Subject: Response to Request for Additional Information Regarding Authorization to Use a TRIGA Element Positioning Device in the TRIGA Basket in the Model No. NAC-LWT Package, U.S. Nuclear Regulatory Commission (NRC) Certificate of Compliance (CoC) No. 9225, when Shipping General Atomic TRIGA Fuel

Docket 71-9225 TAC Number: L24417

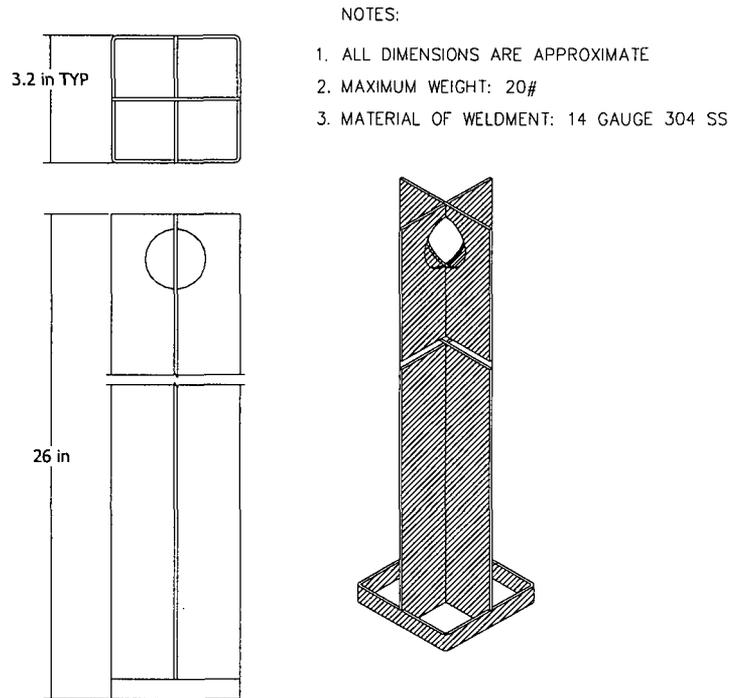
The NRC staff also requested that approximate dimensions and the approximate weight of the cell divider be added to the sketch provided in Reference 3.

NAC has revised the sketch to provide the requested information. As use of the cell dividers will be limited to facilitate loading of instrumented TRIGA fuel element assemblies only, the maximum height of the divider has been changed to approximately 26 inches. The weight of the device is limited to 20 pounds, which is the same as the weight of the damaged fuel can.

Similarly to other handling and support hardware (e.g. Fuel Rod Capsule, TPBAR Waste Container, etc.) approved based on conceptual sketches, NAC does not intend to provide a license drawing for the 304 stainless steel cell divider. The revised sketch is presented below:

The fuel cell divider provides no safety function. Its sole purpose is to facilitate loading and positioning of instrumented TRIGA fuel element assemblies within the TRIGA basket fuel cell.
